Access Compliance Report Public Rights-of-Way (Curb Ramps)

Main Street: CAMERON_LN Cross Street: VANDERLIP_AVE Location: NE

ADA ID: RPRK211228173335 Ramp Type: Type 4 - Parallel Initial Pass/Fail: Fail Overall Compliance: No Severity Score: 15

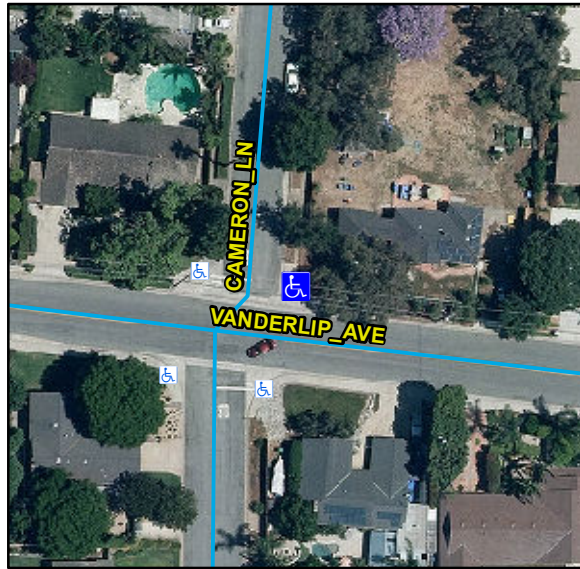
Compliance	Description	Data	Compliance	Description	Data
N/A	Ramp Length LT (in)	95	N/A	Ramp Length RT (in)	88
Yes	Ramp Width LT (in)	92	Yes	Ramp Width RT (in)	92
No	Ramp Run Slope LT (%)	9.3	No	Ramp Run Slope RT (%)	9.6
Yes	Ramp Cross Slope LT (%)	1.7	Yes	Ramp Cross Slope RT (%)	1.9
N/A	Landing Present	N/A	N/A	DWS Provided	N/A
N/A	Landing Length (in)	N/A	N/A	DWS Contrast	N/A
N/A	Landing Width (in)	N/A	N/A	DWS Length (in)	N/A
N/A	Landing Run Slope (%)	N/A	N/A	DWS Full Width	N/A
N/A	Landing Cross Slope (%)	N/A		DWS Offset Type	N/A
N/A	Landing Movement Obstructed?	N/A	N/A	DWS Offset Left (in)	N/A
	Landing Movement Type	N/A	N/A	DWS Offset Right (in)	N/A
N/A	Landing Shared	N/A			
N/A	Clear Space	Yes			
N/A	Clear Space To Crosswalk (in)	N/A			
N/A	Marked Crosswalk 1	No	N/A	Marked Crosswalk 2	No
	Crossing 1 Direction	W		Crossing 2 Direction	S
	Marked Crosswalk 1 Width (in)	N/A		Marked Crosswalk 2 Width (in)	N/A
N/A	Ramp Inside Crosswalk 1	N/A	N/A	Ramp Inside Crosswalk 2	N/A

Remove & Replace Curb Ramp With Two New Directional Ramps or Equivalent.

R204.3, R304.3.2, STD 1115
